The old version of the WAGO 2060 Series is being discontinued and replaced by newer parts.

All SMD and THR PCB Terminal Blocks 2060 Series with short housing and corresponding Board-to-Board Links. The affected article numbers are shown below.

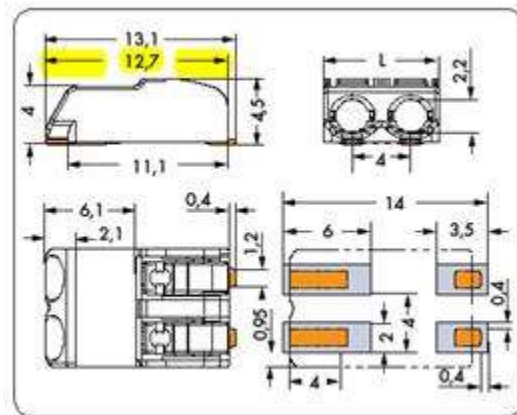
There are successor products available for all discontinued terminal blocks. These products have a housing which is 1mm longer at the back for higher mechanical stability. They can be used without further consideration if there are no other objects placed in that area (see drawing below). The PCB layout as well as technical data and certifications are identical.

Discontinued Version

New Version
